Consultant	Wahib Medanat Consultant Engineer	Rep No.	22-23052022
Contractor	Dijlah Establishment Constr. Contracting	Tender No.	(11/2019/USAID/SKEP/3/S) Schools for a Knowledge Economy Project (SKEP) - Phase (3) Package (1, 2)
Site Name	Thahr Al Sarow Basic School for Boys- Jerash	Day/ Date	Mon. 23/05/2022
Duration of Project	450 Calendar Days	Total Project Budget	8,314,983.735 JD

SKEP III Home Office Support Site Visit Report

(Figure: 10)

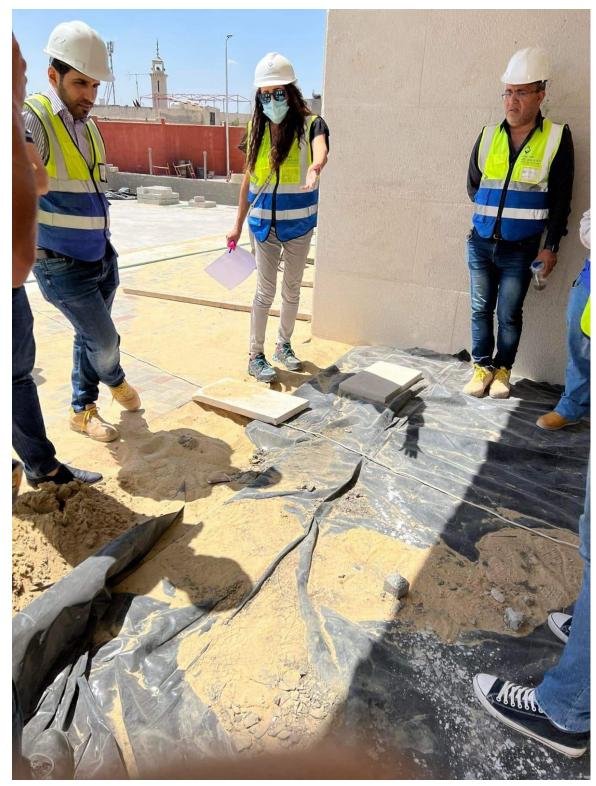
The team stressed that the plastering work for the external walls shall be in full compliance to the Contract's requirements and the related details

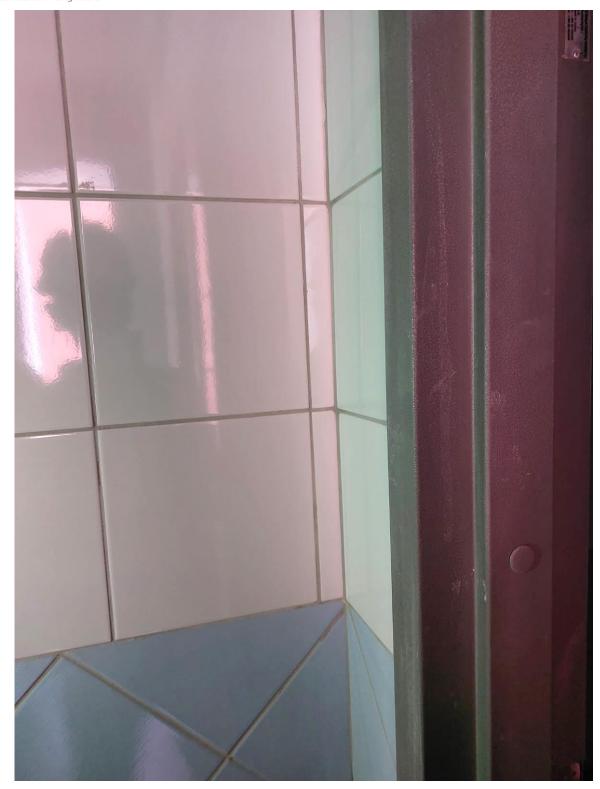
The team observed a number of broken window sills and request the Contractor to repair

The team observed that the wall tiling is some areas has been executed not in compliance with the workshop drawings. That led to cut-off pieces around 2.5.cm which is considered not acceptable

(Figure: 17)

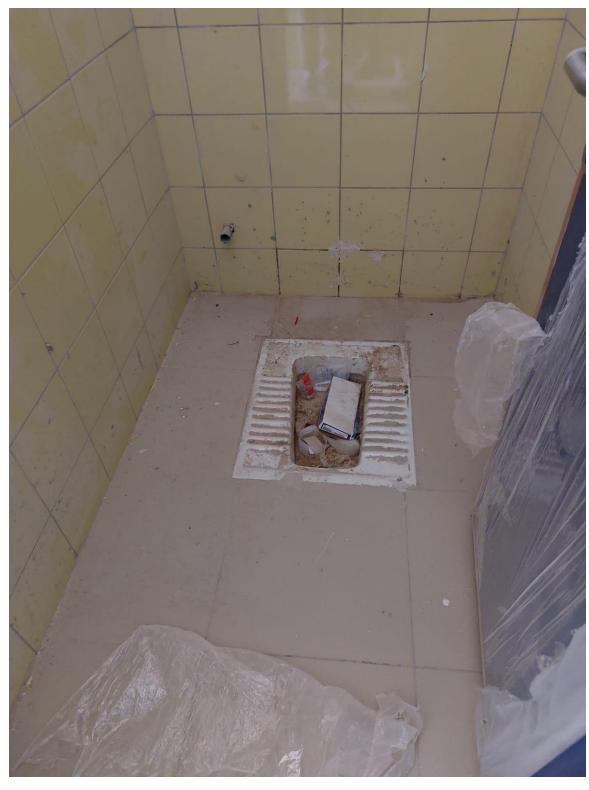
The team observed that the Contractor has not conducted the required rectification to the granite cladding and coping at the corridors and staircases areas
